Addendum No. 2

To: Interested Parties
From: John E. Van Riper, Project Engineer
Division of Engineering
Date: Friday, October 12, 2018
Project: Washington County Employee Parking Facility

Washington County Employee Parking Facility

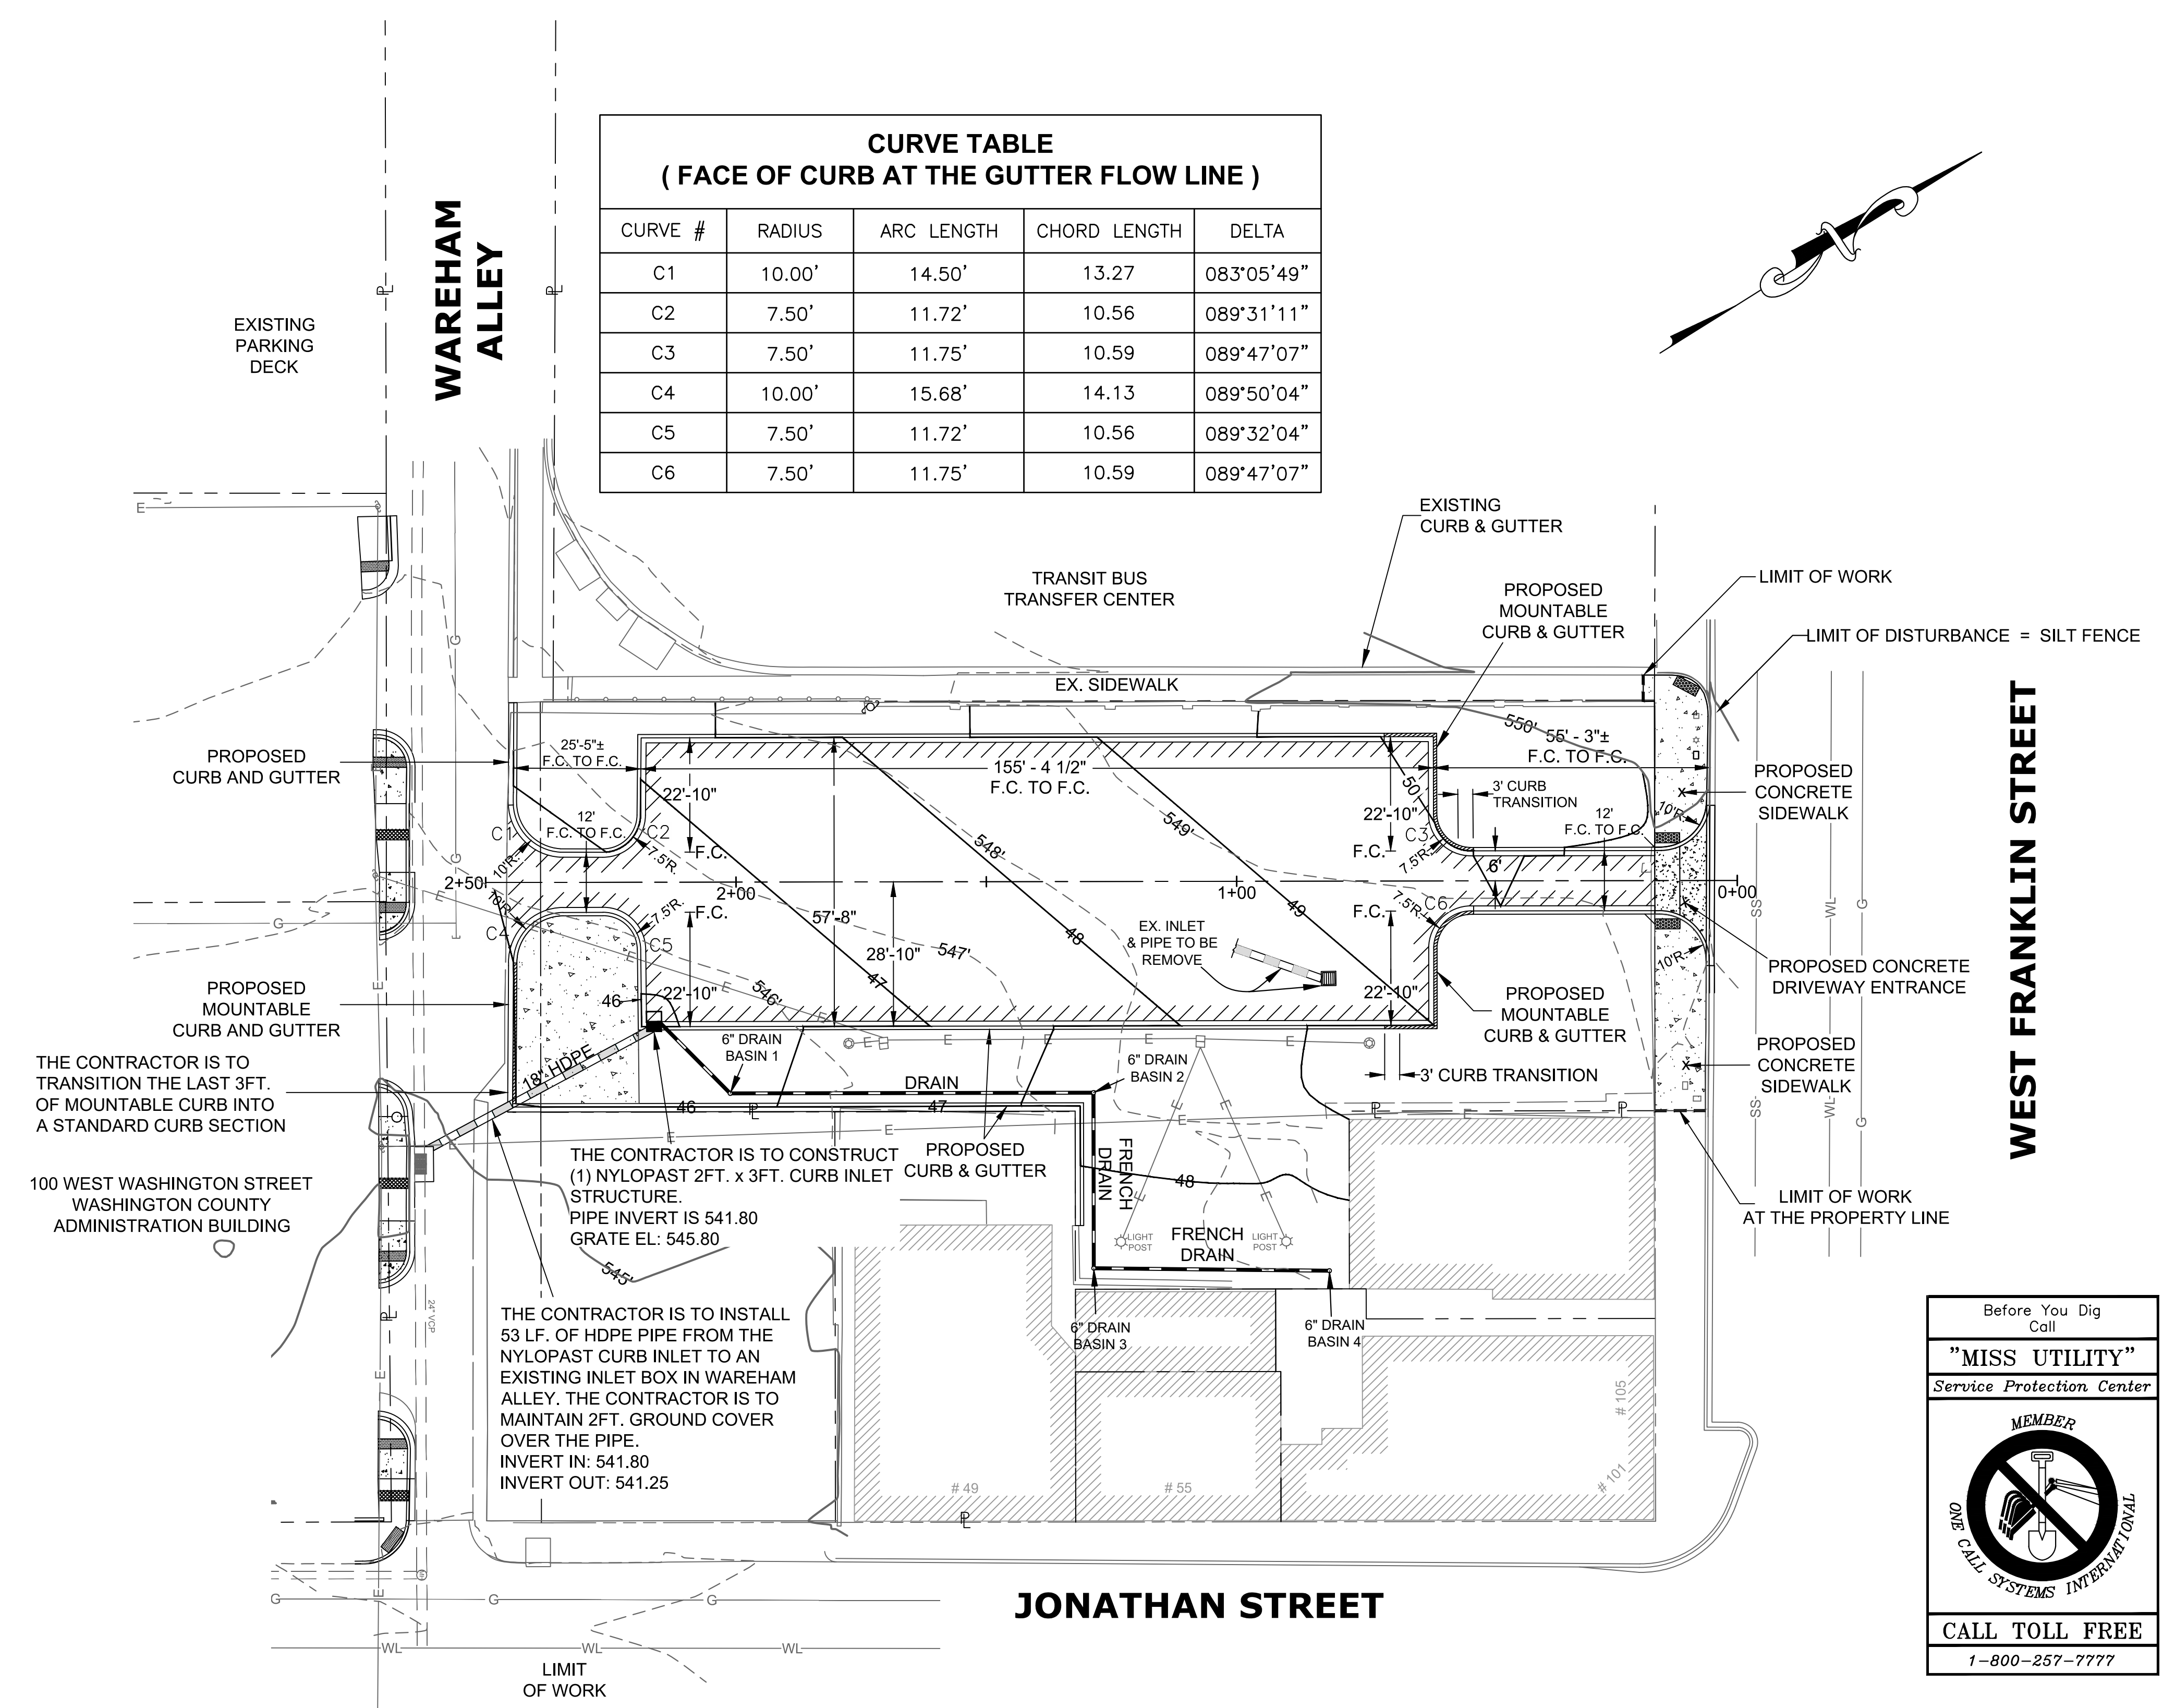
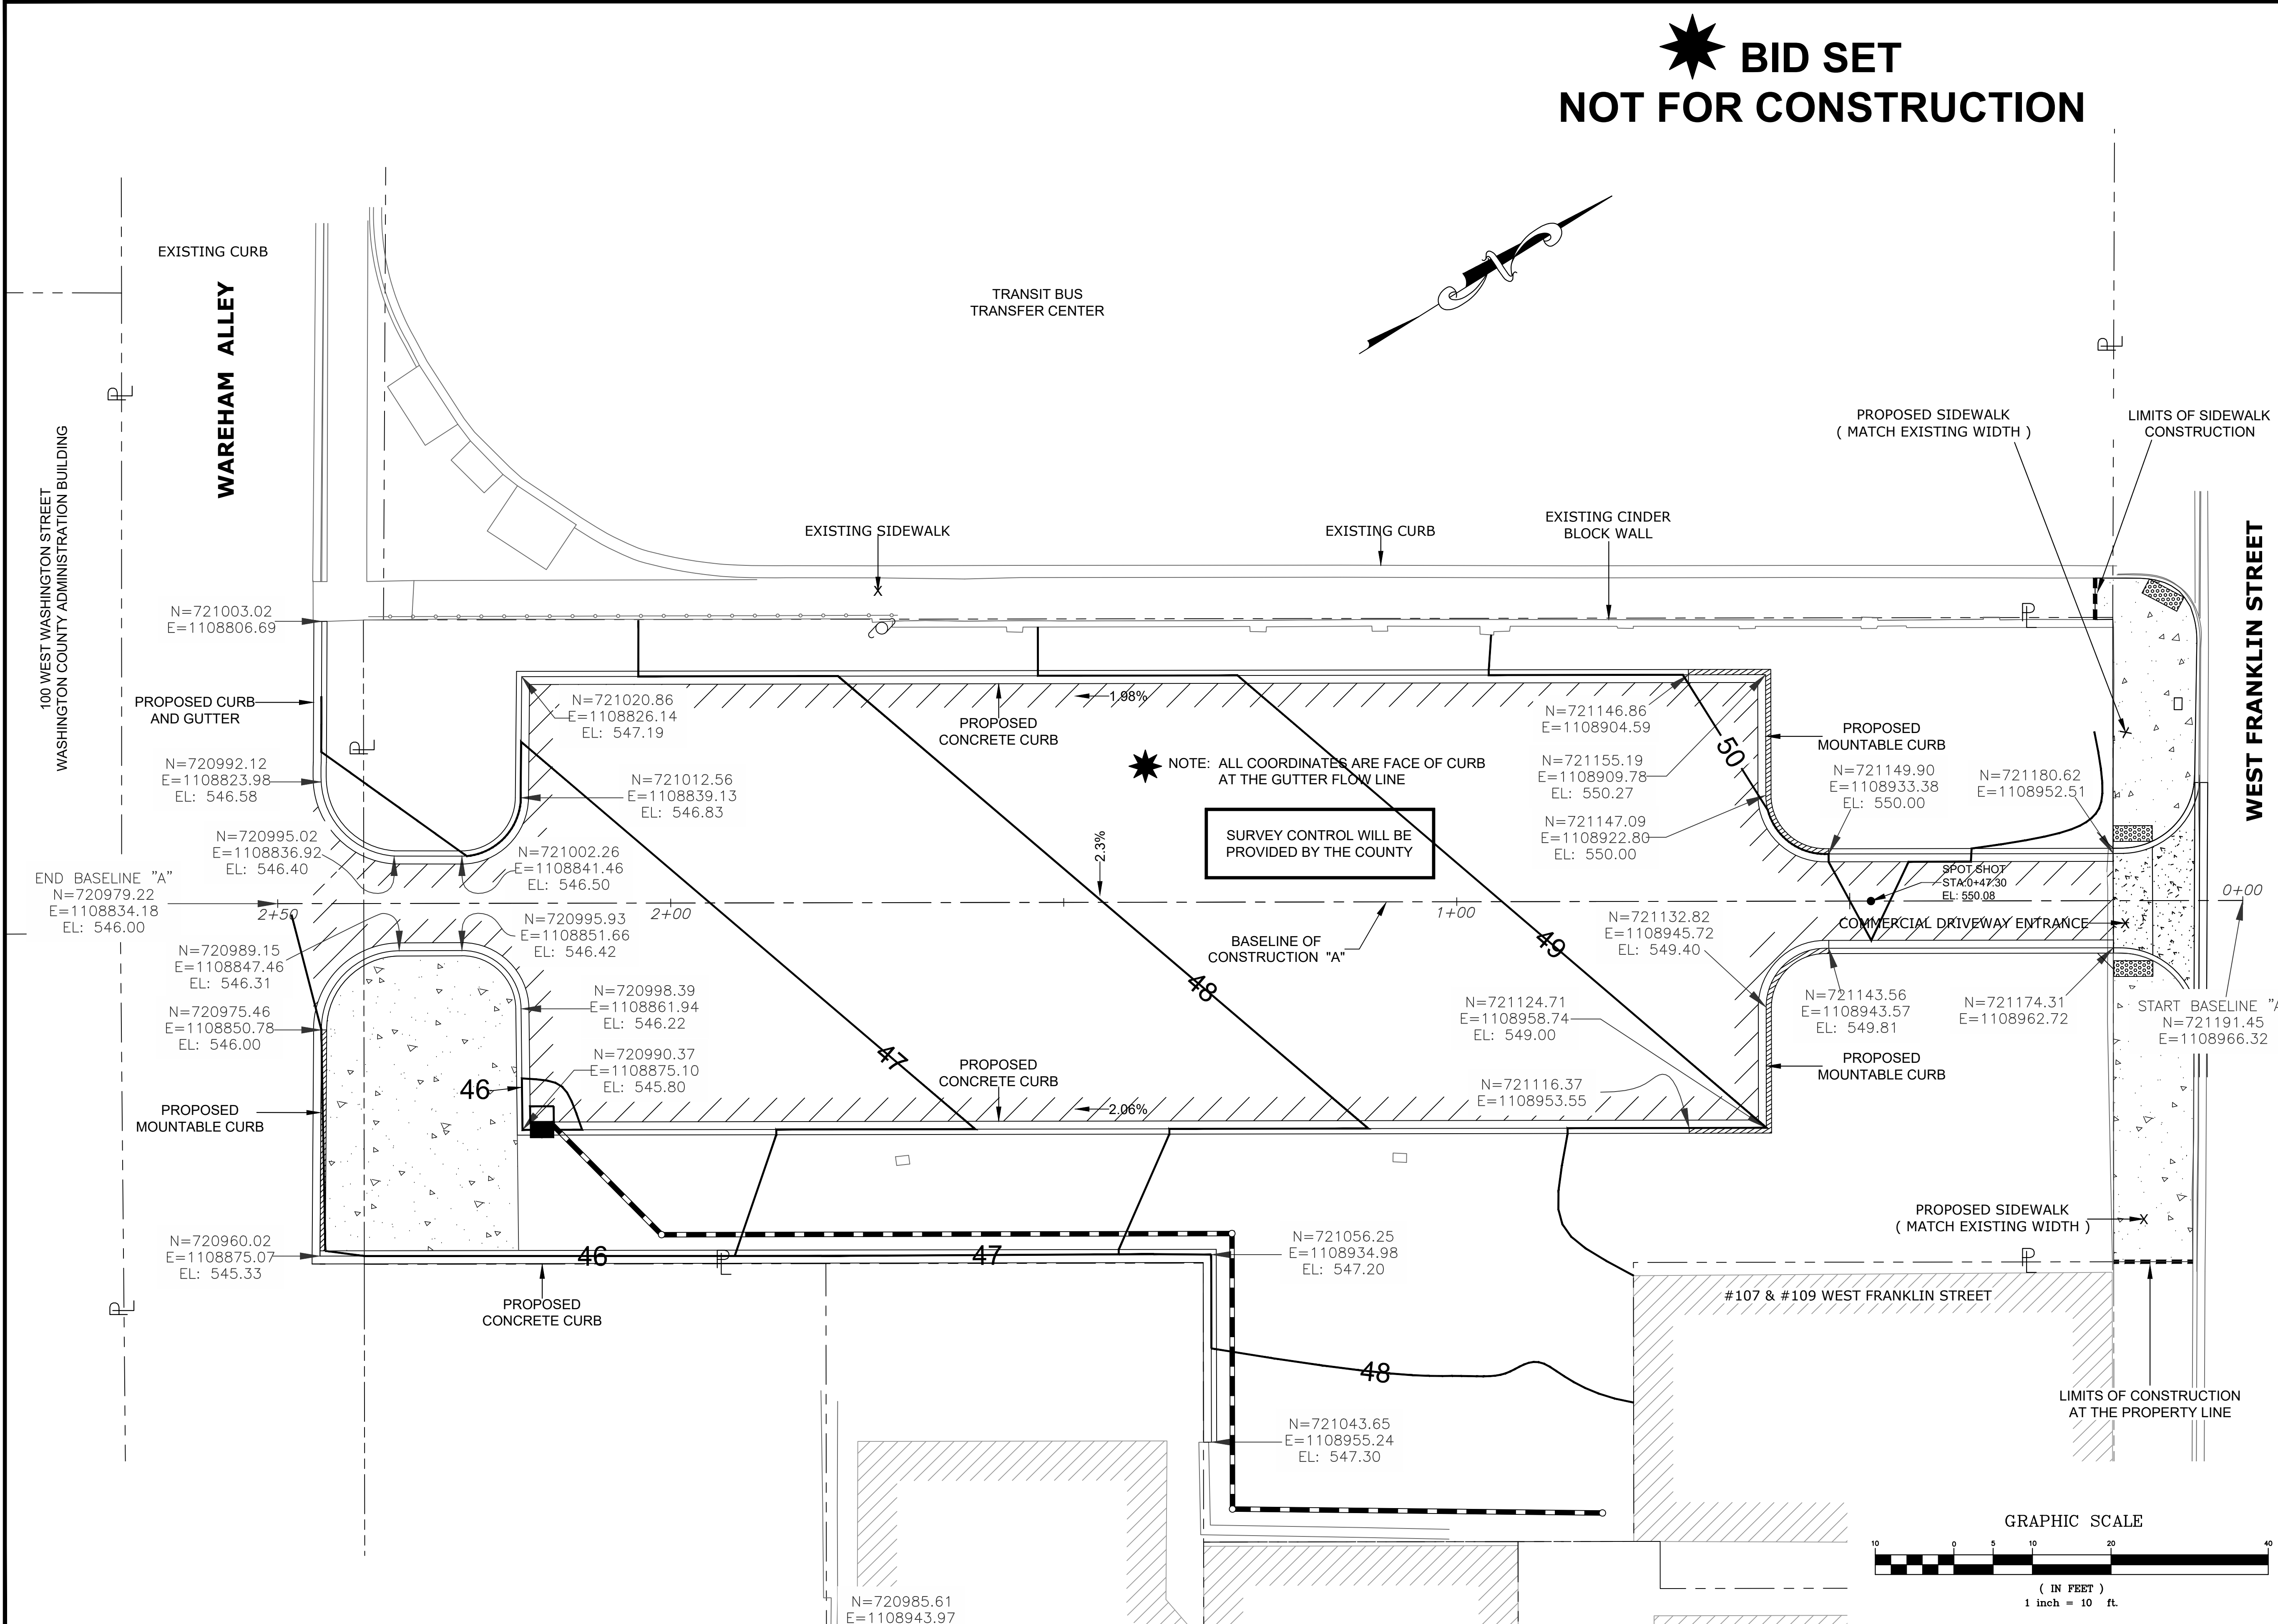
Item 2.12 **Q12 from Don Pyatt of Huntzberry Brothers Inc.: Bid Item #301 indicates Removal of inlets? Dwg #1 of 10 indicates one inlet with piping. Does piping get removed also?** Yes, pipe should be removed with the inlet.

Item 2.15 **Q15 from Don Pyatt of Huntzberry Brothers Inc.: Located the telephone pole to be removed. Located the water meter tile to be removed?** These have been addressed on sheet 1 of the Plans. The water meter tile is located at station 0+18 on the Right Side. The location of the telephone pole to be removed is located at station 1+73 on the Right Side. The telephone pole does not have any utilities attached to it.

- Item 2.17 Plan sheets 1, 2, and 11 have been revised:
- Sheet 1 changes include re-labeling of Drainage system
 - Sheet 2 changes include fixing incorrect elevation labels for coordinates
 - Sheet 3 changes include re-labeling of Drainage system and Stationing

COORDINATE PLAN

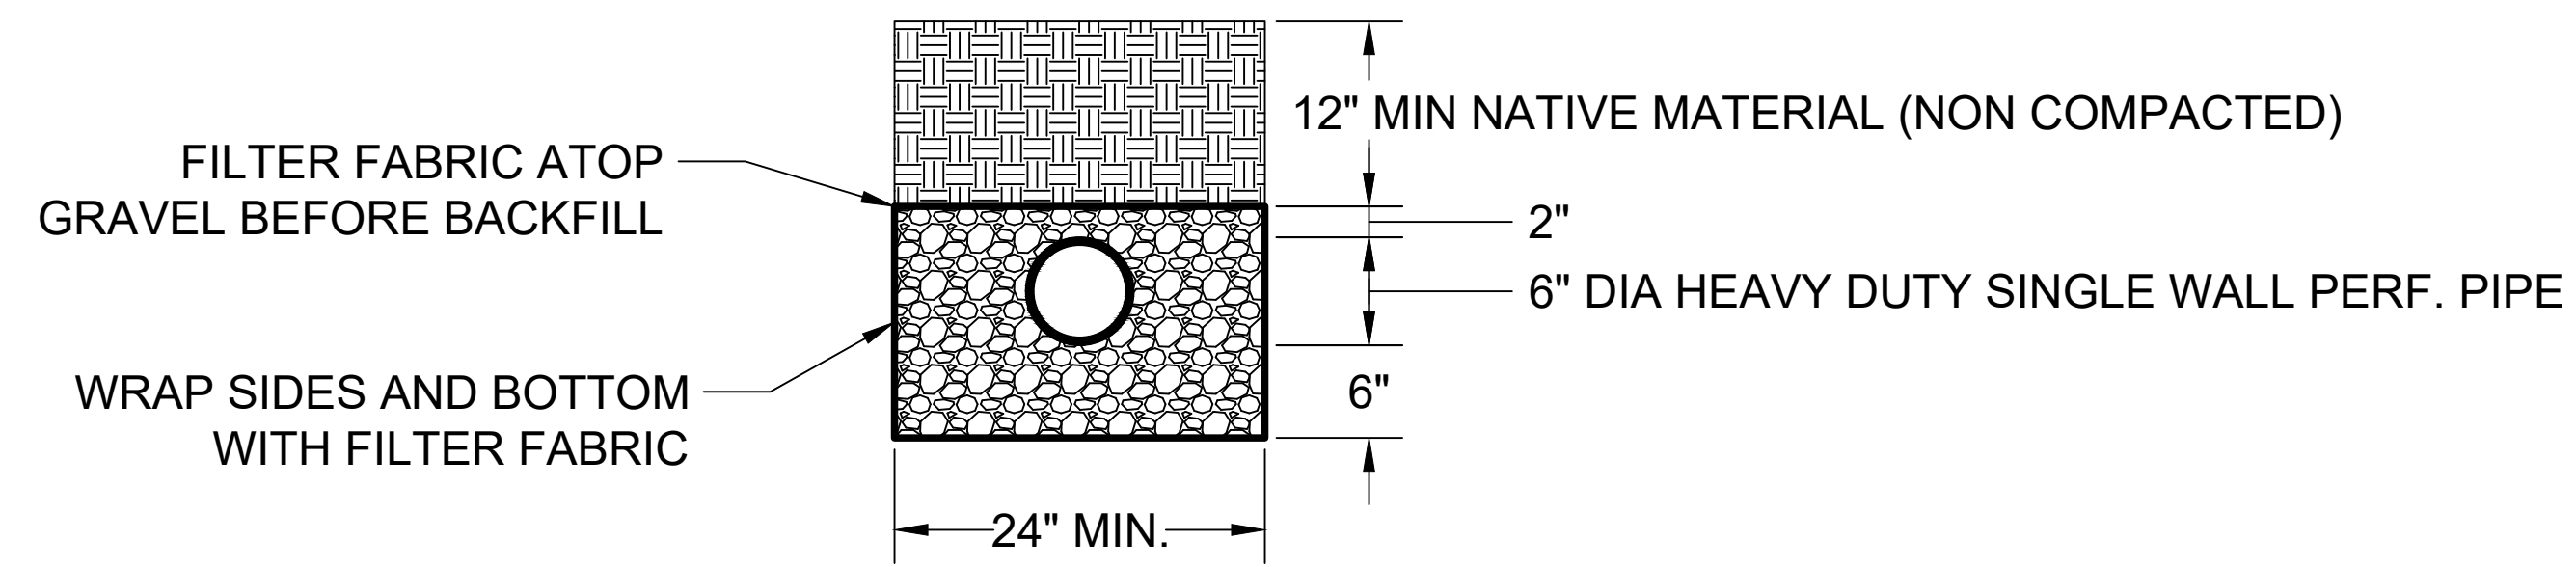
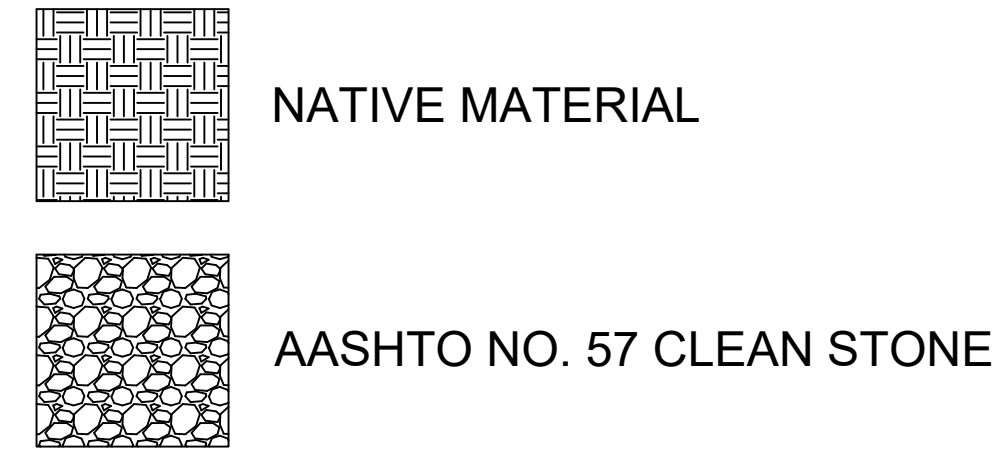
Item 2.11 **Q11 from Don Pyatt of Huntzberry Brothers Inc.: Drawing #2 of 10 incorrect scale?** Yes, this should be a 1 inch = 10 ft. scale, not 1 inch = 20ft. Please see Attachment "C" for revised drawings
